Value Engineering Study Report

Georgia Department of Transportation
CSSTP-0007-00(414) - P.I. No. 0007414

**CR90/ Colerain Road from I-95 to Kings Bay Road
Camden County**

RE: Submittal of the final Value Engineering Report
Colerain Road from I-95 to Kings Bay Road
Project Nos.: CSSTP-0007-00(414) – P.I. No. 0007414

ALTERNATIVE NO.:
BR-1

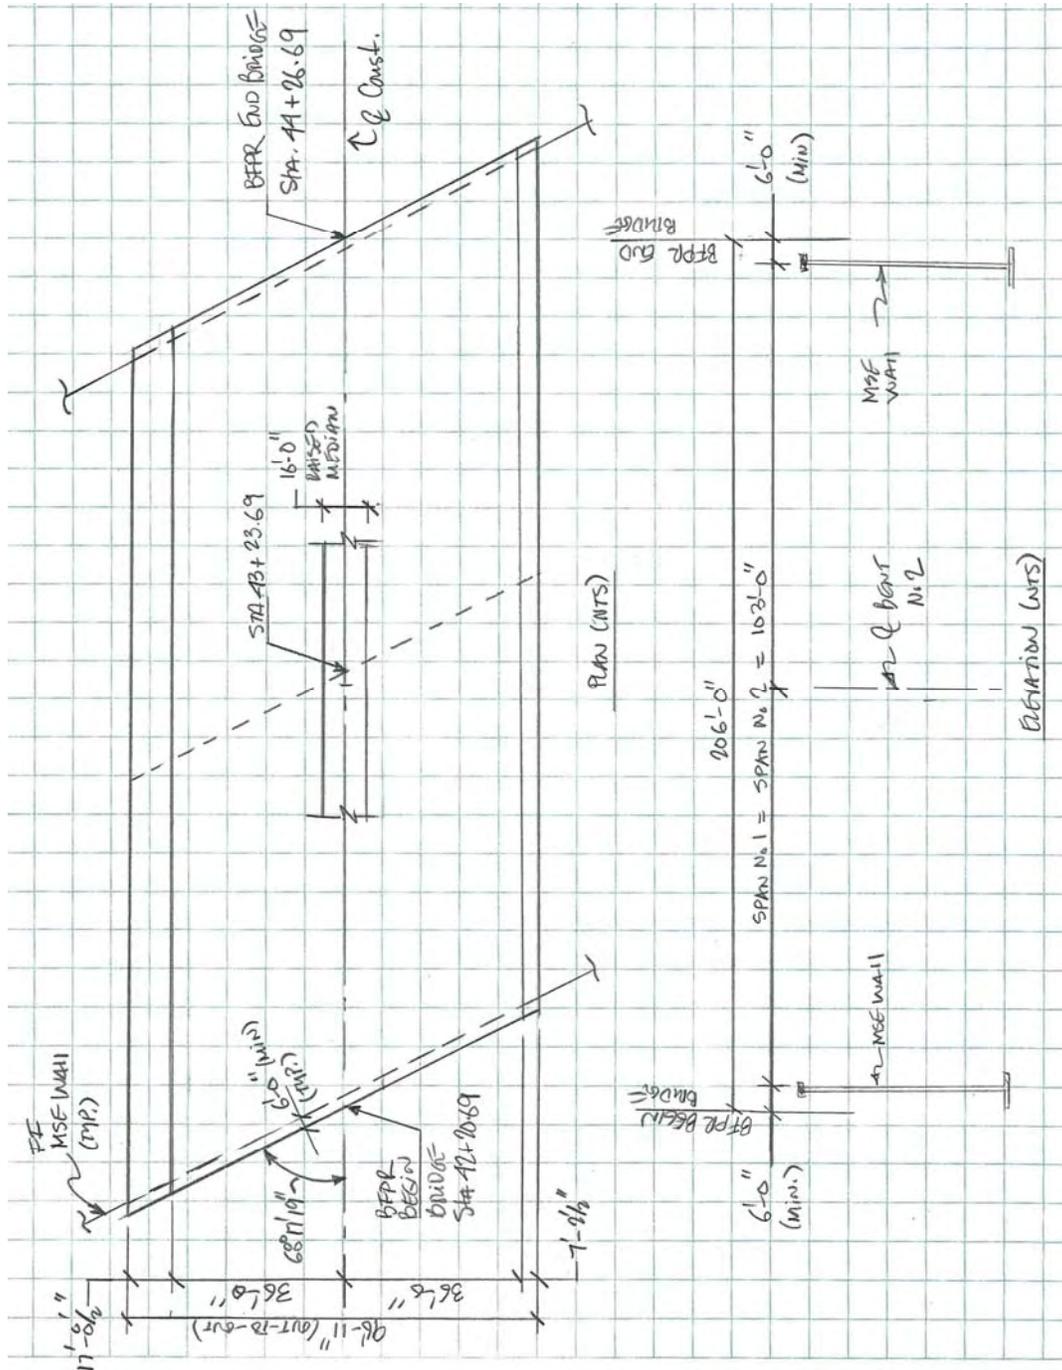
The original design calls for a four span (48'-0", 98'-6", 98'-6", 48'-0") bridge structure to cross over I-95. The 293'-0" long bridge will have a CIP superstructure supported by 11- PSC 54" Bulb Tees beams spaced at 9'-0". The overall out-to-out width is 96'-11" and it will provide two sidewalks (6'-0" and 16'-6"), four-12'-0" traffic lanes (two on each direction), one 16'-0" inside median and two 2'-0" shoulders. The bridge will be on a 68°-17'-19" skew. All bents are parallel.

The alternative design calls for a two span (103'-0", 103'-0") bridge structure to cross over I-95. The 206'-0" long bridge will have a CIP superstructure supported by 12- PSC 54" Bulb Tees beams spaced at 8'-1". The overall out-to-out width is 96'-11" and it will provide two sidewalks (6'-0" and 16'-6"), four-12'-0" traffic lanes (two on each direction), one 16'-0" inside median and two 2'-0" shoulders. The end bent fills will be retained by MSE walls running parallel to the I-95. The bridge will be on a 68° - 17'-19" skew. All bents are parallel.

The use of MSE walls will help reduce the proposed bridge length. The overall sequence of construction will not change and as a result from the reduction in overall bridge length and beam spacing less material will be used.

ALTERNATIVE NO.:
BR-2

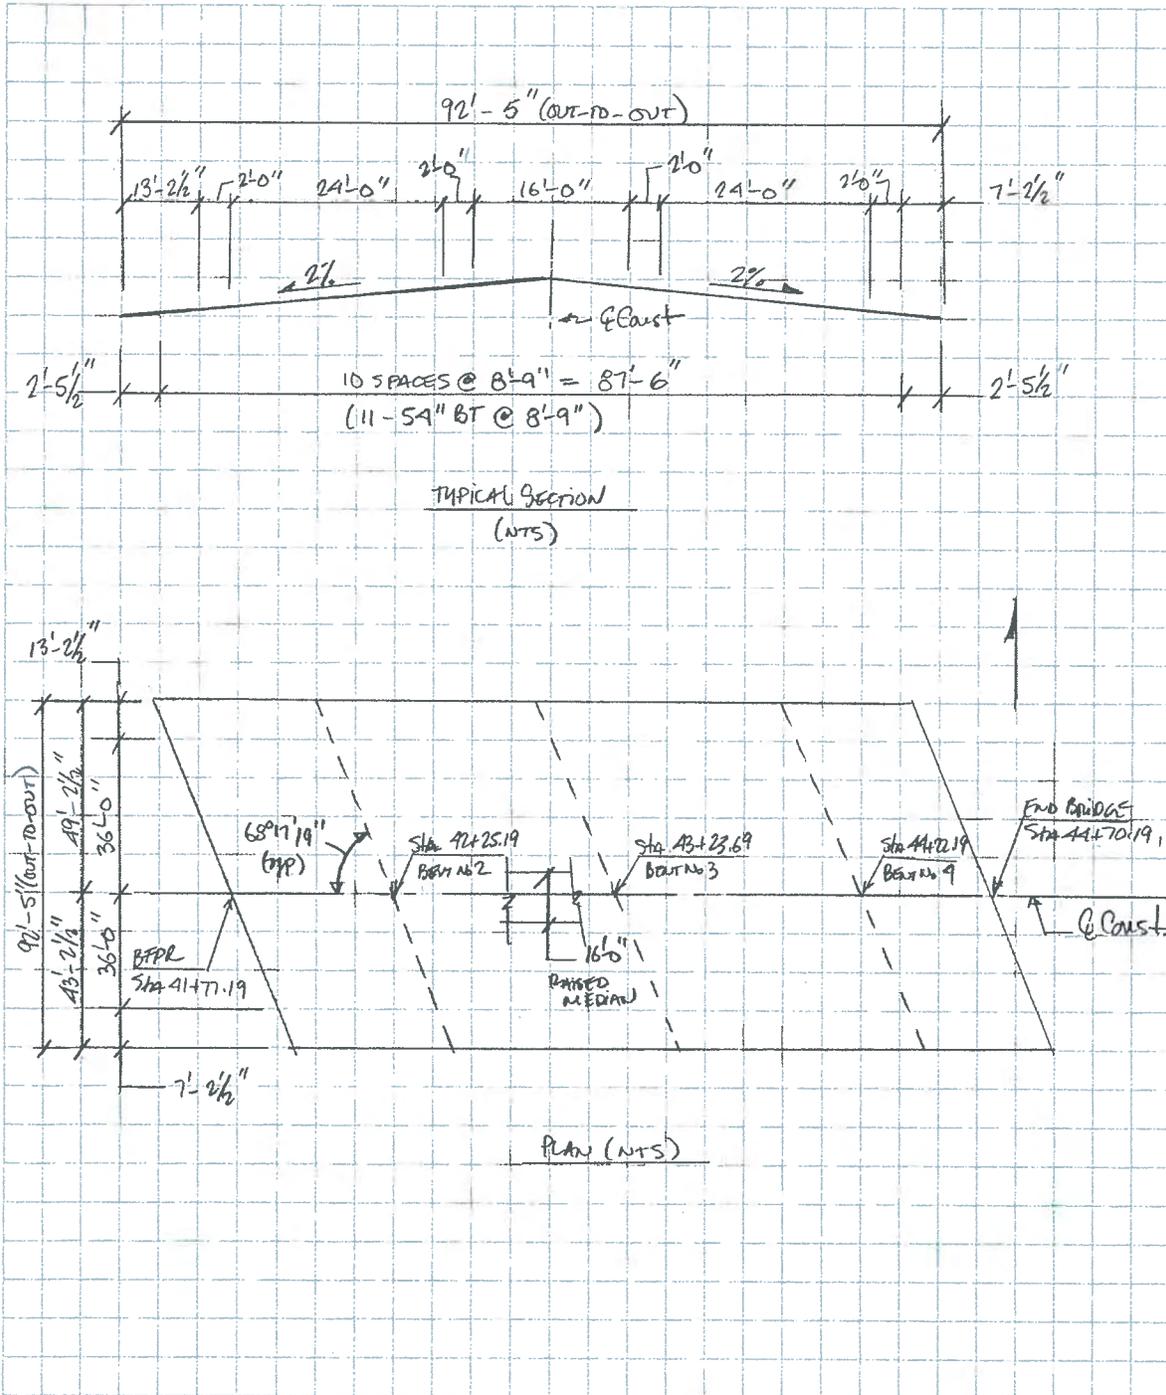
The alternative calls for the reduction in width for the Multi-Use Trail from 16'-6" to 12'-0". The 293'-0"-0" long bridge will have a CIP superstructure supported by 11- PSC 54" Bulb Tees beams spaced at 8'-9". The overall out-to-out width is 92'-5" and it will provide two sidewalks (6'-0" and 12'-0"), four-12'-0" traffic lanes (two each direction), one 16'-0" inside median and two 2'-0" shoulders. The bridge will be on a 68°-17'-19" skew. All bents are parallel.

The proposed alternative will reduce the overall bridge width from 96'-11" to 92'-5".

ALTERNATIVE NO.:
BR-3

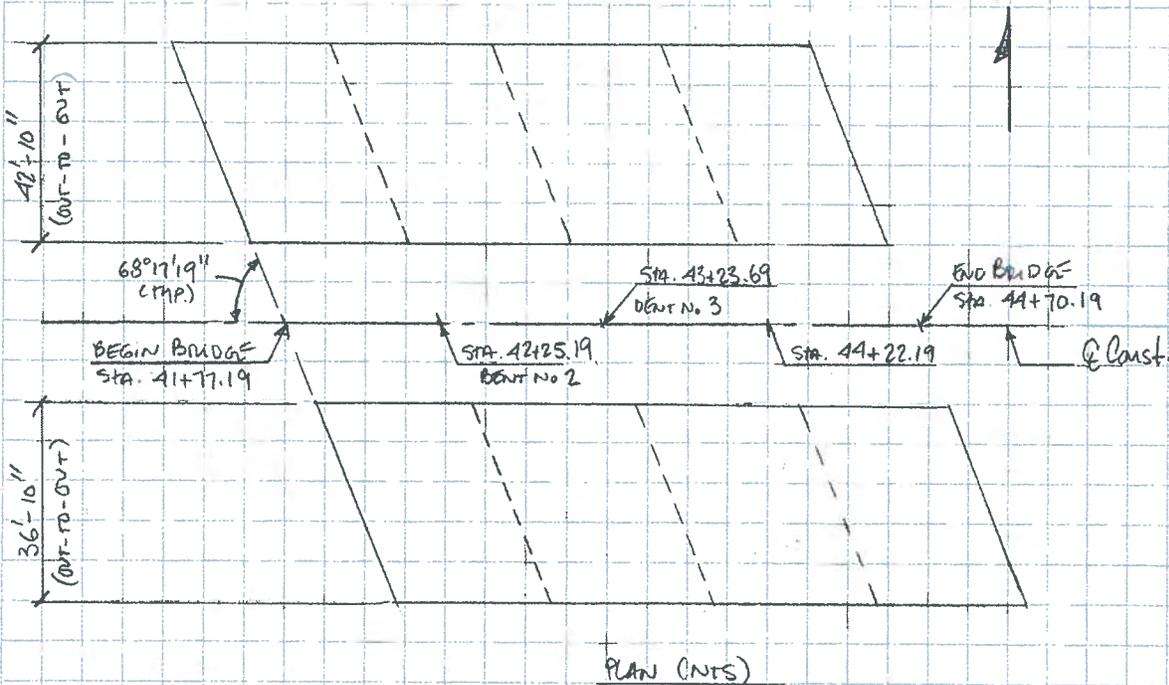
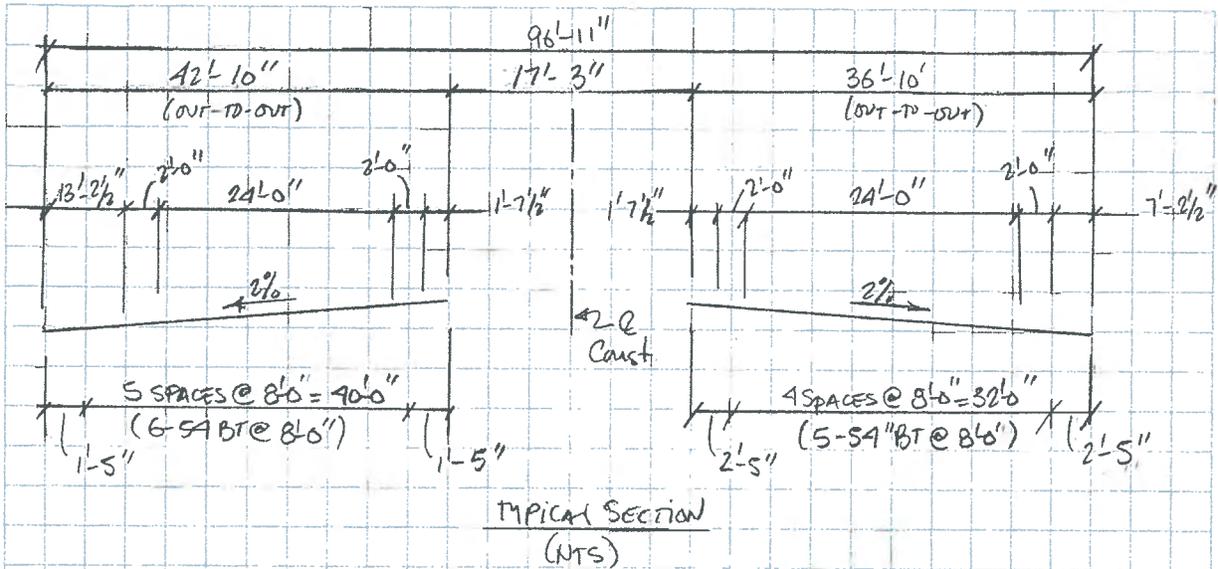
The alternative calls for two four span (48'-0", 98'-6", 98'-6", 48'-0") twin bridge structures to cross over I-95. The North bridge will have an overall out-to-out width of 46'-10" and it will provide a sidewalk (12'-0"), two-12'-0" traffic lanes and two 2'-0" shoulders. A total of 6-54" Bulb Tees spaced at 8'-0" will support the CIP superstructure. The South bridge will have an overall out-to-out width of 36'-10" and it will provide a sidewalk (6'-0"), two-12'-0" traffic lanes and two 2'-0" shoulders. A total of 5-54" Bulb Tees spaced at 8'-0" will support the CIP superstructure. Both bridges will be on a 68°-17'-19" skew. All bents are parallel.

The use of twin bridges will provide saving in construction cost. The use of twin bridges will eliminate the need of the 16'-0" raised median and temporary barriers. Additionally, this alternative calls for the reduction in width for the multi-use trail from 16'-6" to 12'-0" (North Bridge).

ALTERNATIVE NO.:
DR-3

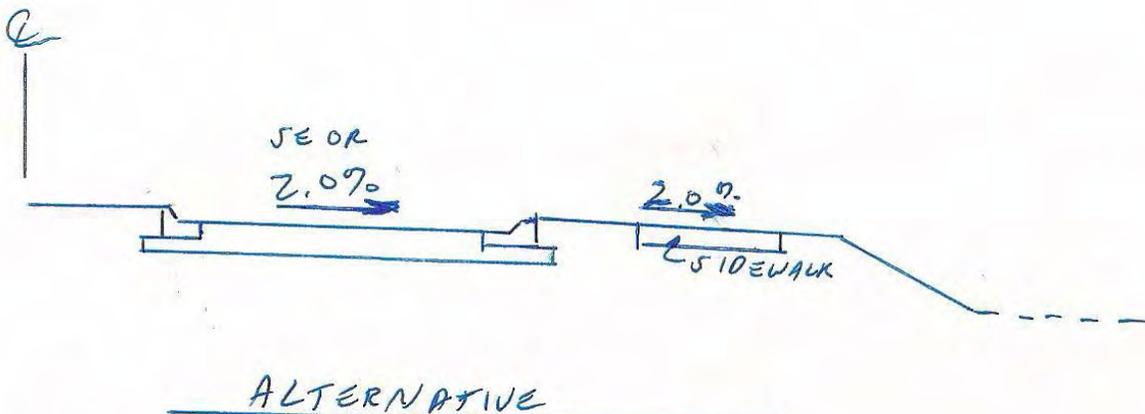
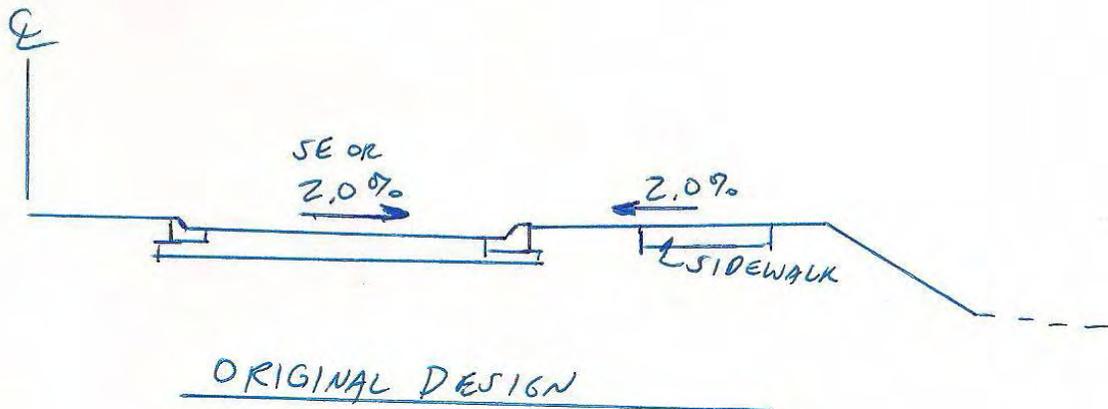
Alternative: Revise the slope of the fill shoulder to drain away from the roadway.

The current natural drainage pattern allows sheet flow off of the roadway. The original design will modify the natural pattern by capturing flow in catch basin and release concentrated flows at new discharge points. Allowing the shoulder to sheet flow away from the roadway, will more closely match the existing drainage patterns and will reduce the amount of concentrated flow in the closed systems by up to 25% being discharged to new points.

ALTERNATIVE NO.:
RD-2

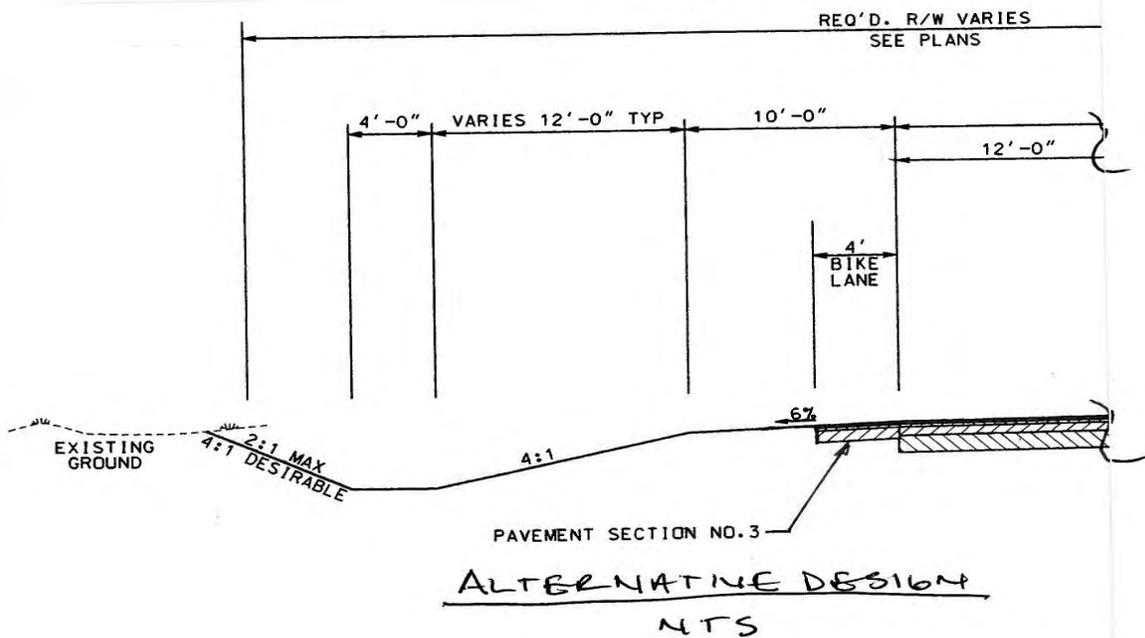
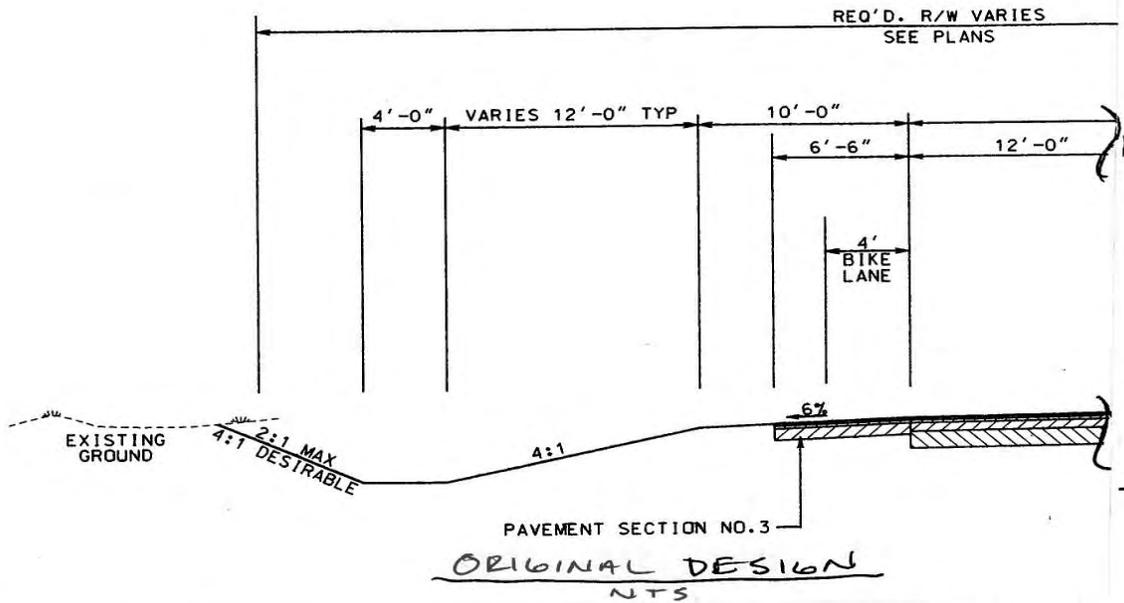
The alternative design would provide a 4'-0" paved shoulder from Station 251+00 to Station 324+50

ALTERNATIVE NO.:
RD-3

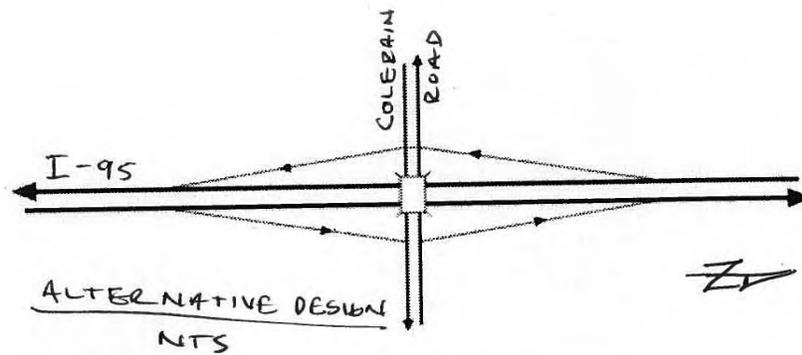
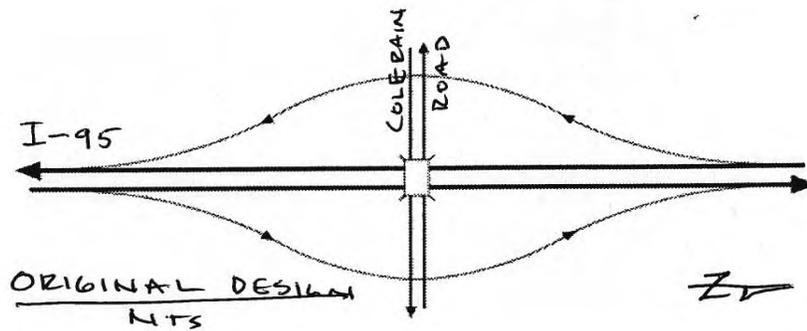
PROJECT:	Georgia Department of Transportation CSSTP-0007-00(414) - P.I. No. 0007414 CR90/Colerain Road from I-95 to Kings Bay Road Camden County	ALTERNATIVE NO.:
		RD-3
DESCRIPTION:	Reconstruct ramps as a Tight Urban Diamond	SHEET NO.: 4 of 4

ALTERNATIVE NO.:
RD-12

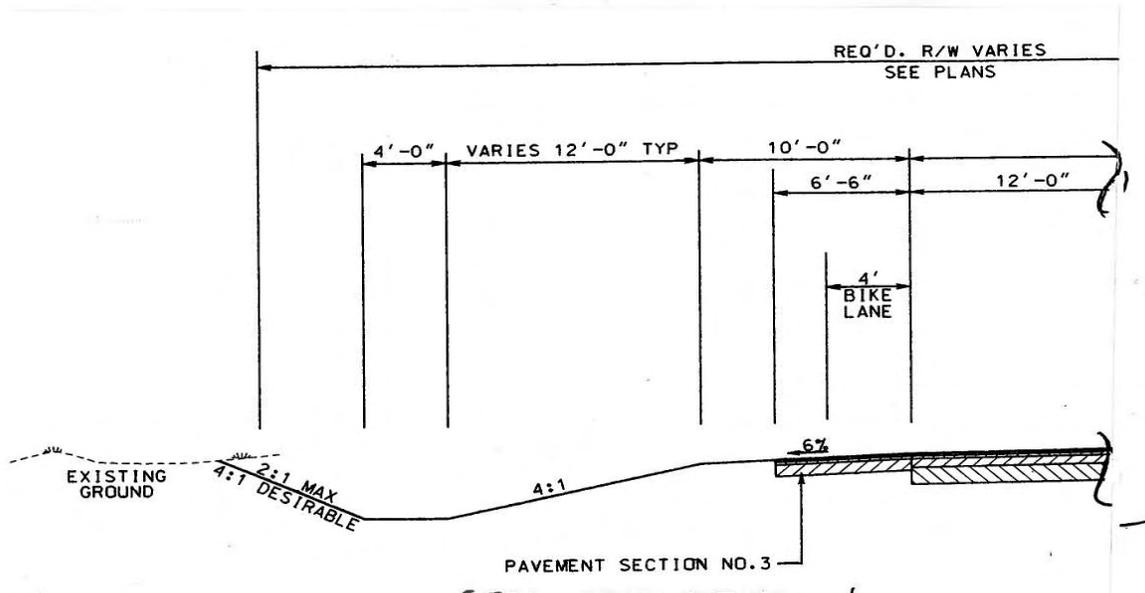
PROJECT:	Georgia Department of Transportation CSSTP-0007-00(414)) – P.I. No. 0007414 CR90/Colerain Road from I-95 to Kings Bay Road Camden County	ALTERNATIVE NO.:	RD-12
DESCRIPTION:	Utilize the rural typical section from Station 186+21 to Station 251+00	SHEET NO.:	1 of 4

ALTERNATIVE NO.:
RD-16

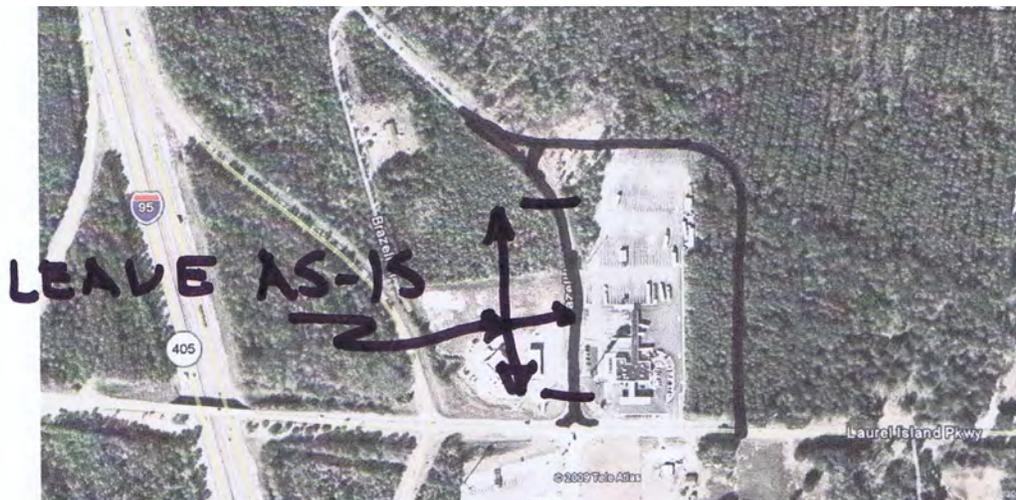
The original design requires construction on Brazell Road for entire the length of the roadway. At this point in the plan development, the Typical Sections for all of Brazell Road have not been developed. It is assumed that new full-depth roadway is required at the tie-ins with Relocated Brazell Rd and the Mainline and the remaining roadway is being overlaid.

ALTERNATIVE NO.:
RD-19

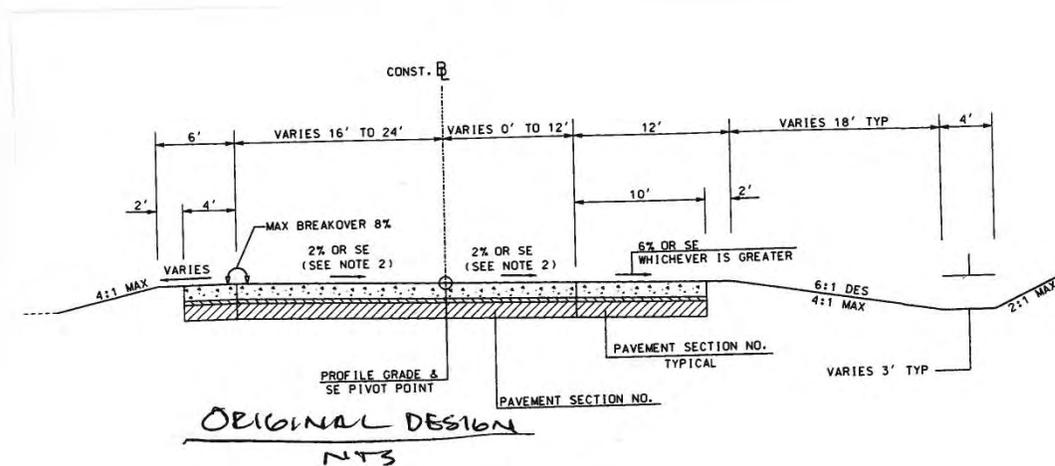
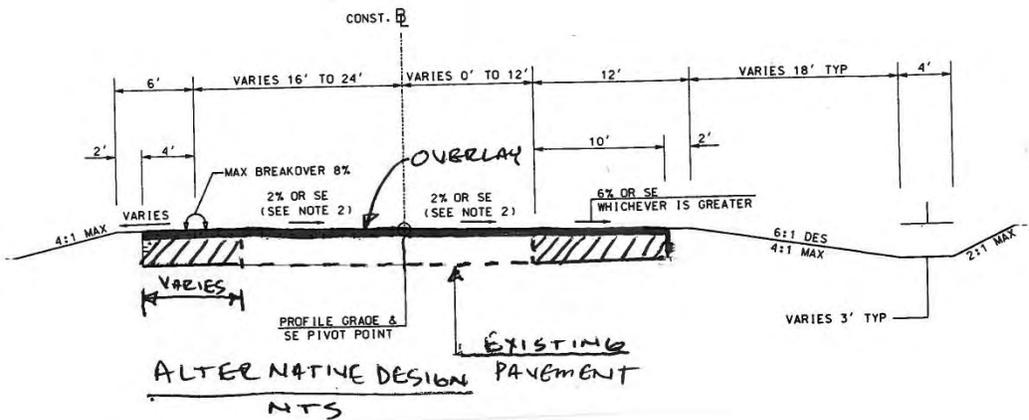
PROJECT:	Georgia Department of Transportation CSSTP-0007-00(414) - P.I. No. 0007414 CR90/Colerain Road from I-95 to Kings Bay Road Camden County	ALTERNATIVE NO.:	RD-19
DESCRIPTION:	Overlay existing ramps and widen to the inside	SHEET NO.:	4 of 4
